City of Nedlands

PD44.13 - Attachment 1 - Locality Plan

PROPOSED RESIDENCE FOR P & B CORNER #20 SWANSEA STREET, SWANBOURNE

PROPOSED MULTI-RESIDENTIAL DEVELOPMENT
LOT 60, ALFRED ROAD, SWANBOURNE
204 APARTMENTS
SITE AREA: 6570m²

SITE PLAN

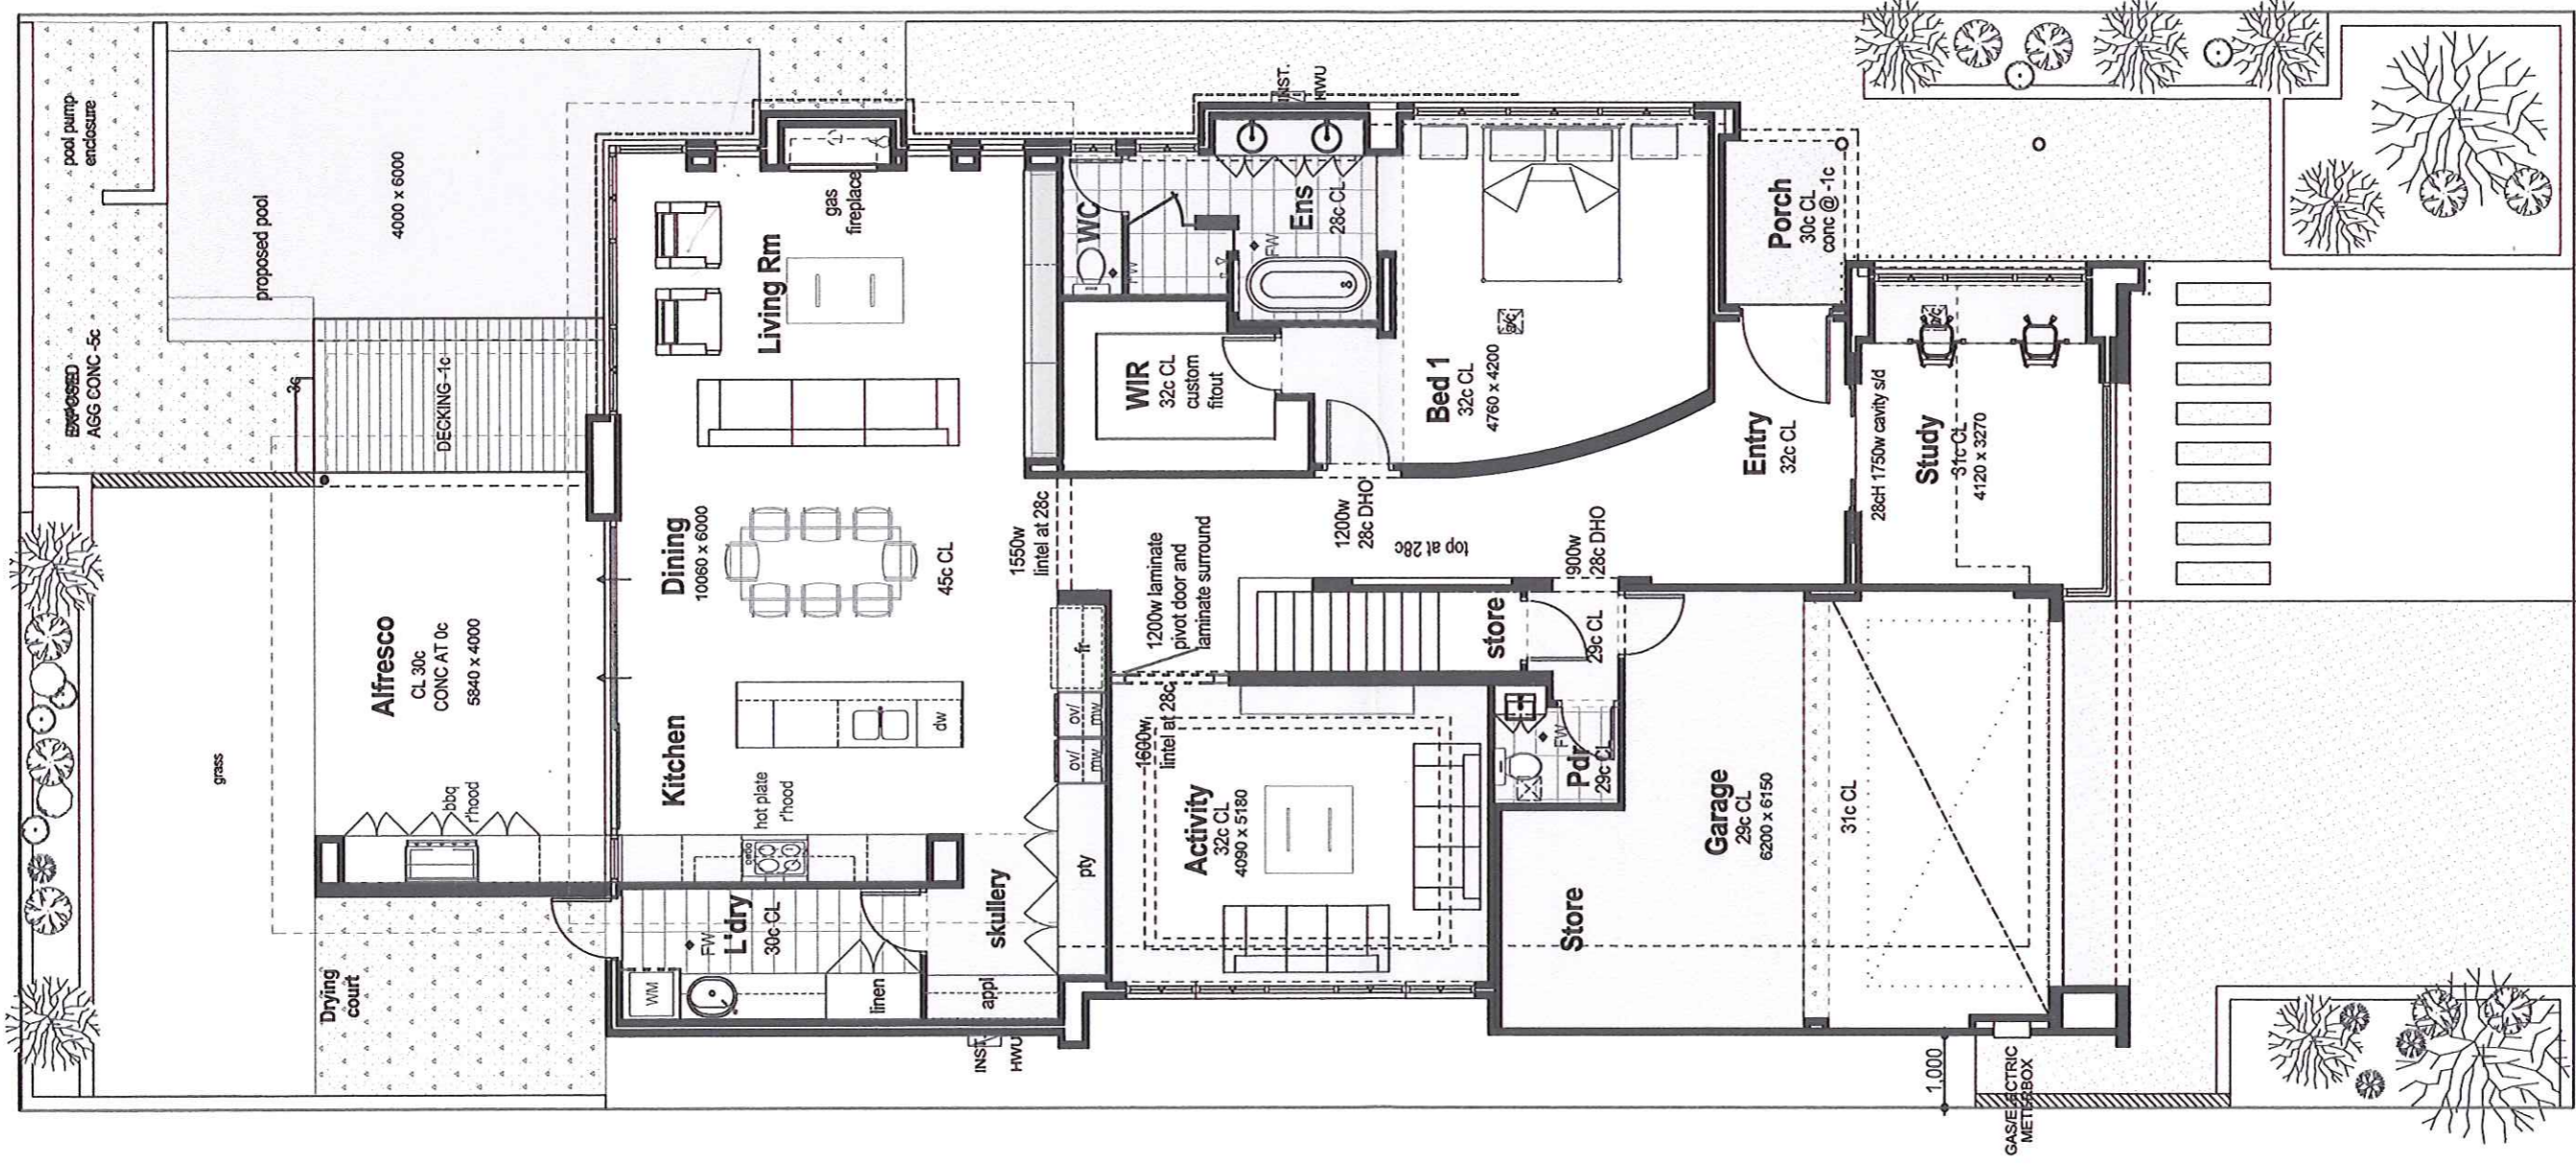
I DO/DO NOT OPPOSE THE ALFRESCO ENCROACHING WITHIN THE 6M REAR SETBACK AS SHOWN ON THE SITE PLAN

- As the Alfresco is offset to the left of the house it was considered this would reduce the impact on the right hand neighbours.
- The alternative to this proposal would be to delete the Alfresco area as a structure and move the rear of the house back to a 6m setback and incorporate an entertaining area within that remaining space. I think this would have a far greater impact on the adjoining neighbours entertaining areas.

1. Active Frontage Facing the Public Realm (Western Street)

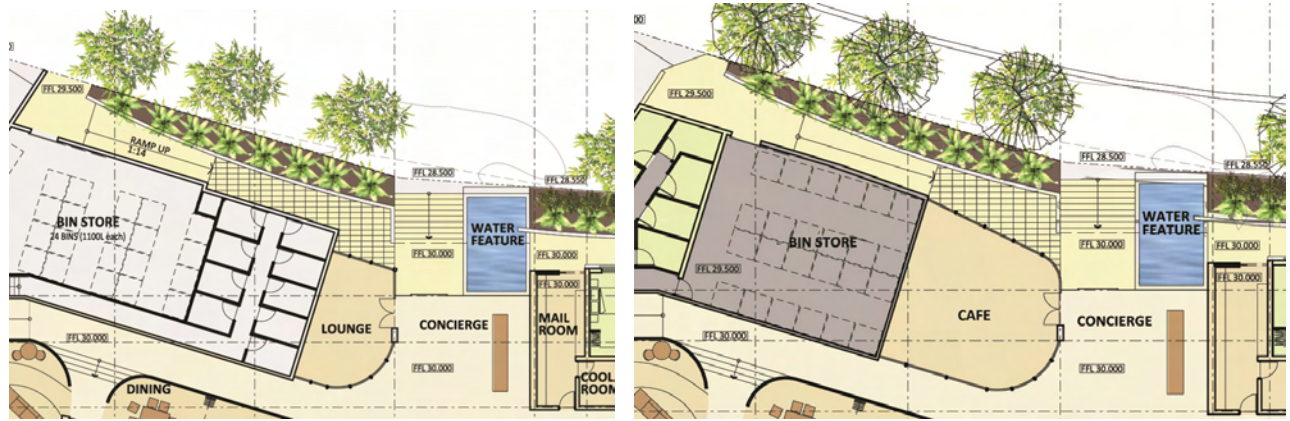
The western elevation at ground level facing the street and south of the main pedestrian entry to the building includes a long length of non habitable blank frontages (stores, centralised bin area and ramp to the lower levels).

It's acknowledged that the ramp location and screened bin store area are required to be adjacent to the street for vehicular access and collection of refuse respectively, however an increase to the active frontage with glazed openings at ground level is sought, particularly through the relocation of the stores at minimum.

It's suggested that a dwelling unit with habitable rooms and openings to be located here facing the street or an appropriate facility for the residents, again with glazed openings to provide visual interest and opportunities for passive surveillance. An alternative design solution would be considered by the SDC to meet this requirement.

The proposed design at ground floor level has been modified to reflect the comments received from the SDC:
